MAPS TEST PCB SCHEMATICS REVIEW

SPI

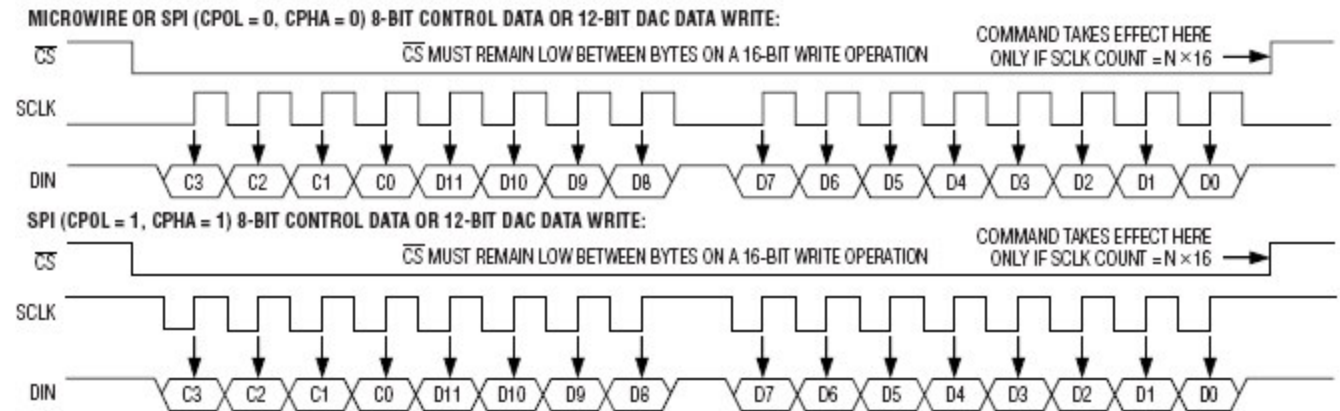
Daisy chain:

DOUT needs to be configured

waveforms for Matt

Connectors

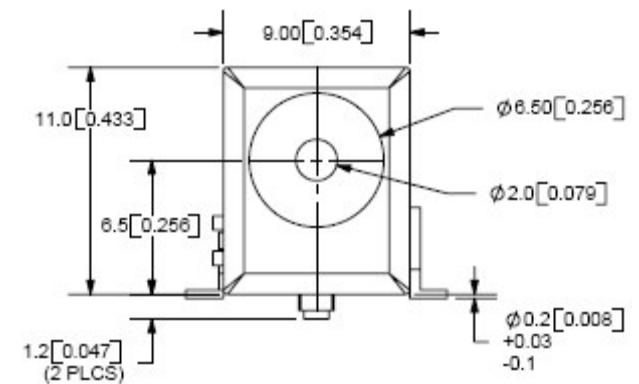
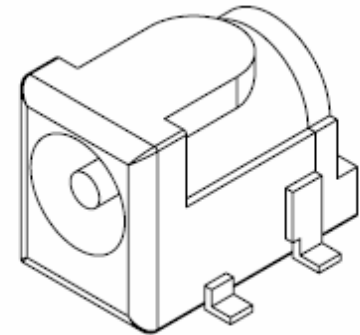
- Signal connector -> 220way
 - ▶ no match so far
- Power supply -> tbd
 - ▶ low profile? how much low is low?
- Logic Analyzer -> two connectors?
